HISTORIC AND DESIGN REVIEW COMMISSION

July 20, 2016

Agenda Item No: 16

HDRC CASE NO: 2016-272
COMMON NAME: 1805 E Hildebrand
LEGAL DESCRIPTION: NCB 49 BLK LOT W IRR 423.51 FT OF A32 & A33
ZONING: C3 HE RIO-1
CITY COUNCIL DIST.: 2
LANDMARK: Miraflores Park
APPLICANT: Joe Cannata, RLA/RVK Architects
OWNER: Bill Pennell/City of San Antonio Parks and Recreation Department
TYPE OF WORK: Stone and monument restoration, landscaping and hardscaping
REQUEST:

L-100

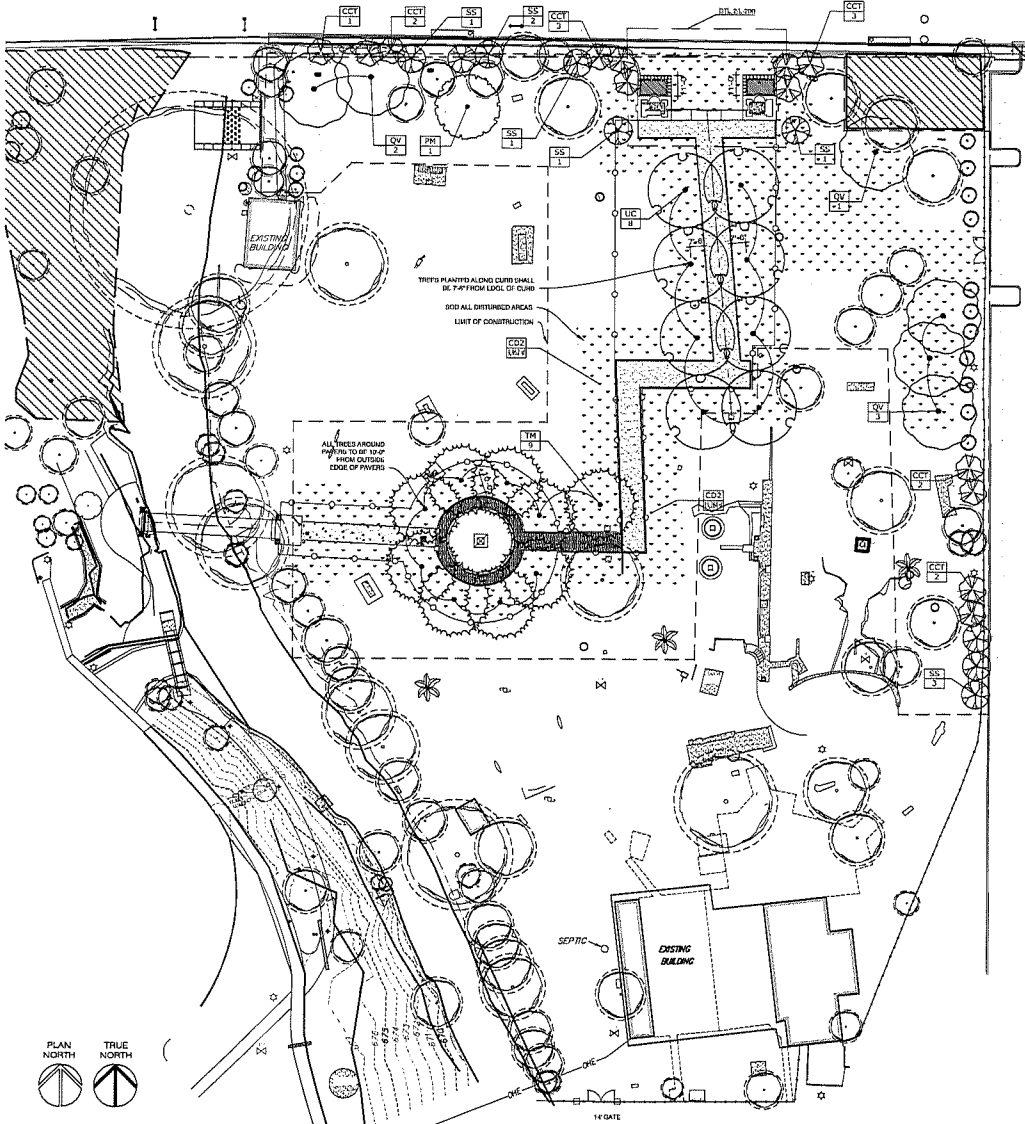
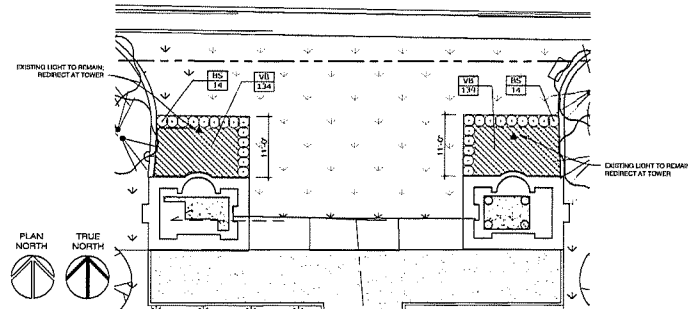
- b. The applicant has provided a hardscaping plan which includes a concrete path from the Dr. Urrutia sculpture to the existing pedestrian bridge over the San Antonio River, the excavation and reuse of historic brick pavers to be used around the Dr. Urrutia sculpture, the installation of a decomposed granite pathway leading from the proposed brick paver area to the entrance at E Hildebrand Avenue and the installation of concrete foundations for the existing column art pieces. The applicant has noted that if the existing bricks and concrete curbs are found to be in a non-reusable condition, new matching bricks and concrete will be used. The applicant has proposed for the decomposed granite walkway to be 14'-0" and 12'-0" in width. The proposed brick paver walkway is to be 10'-0" in width. Staff finds the applicant's proposed hardscaping appropriate and consistent with the UDC.

- c. Along the proposed pathway, the applicant has proposed to install post and cable barriers. The applicant has provided staff with information regarding the proposed post and cable barriers and noted that the height will be thirty-six (36) inches in height.

Staff recommends approval as submitted based on findings a through e.
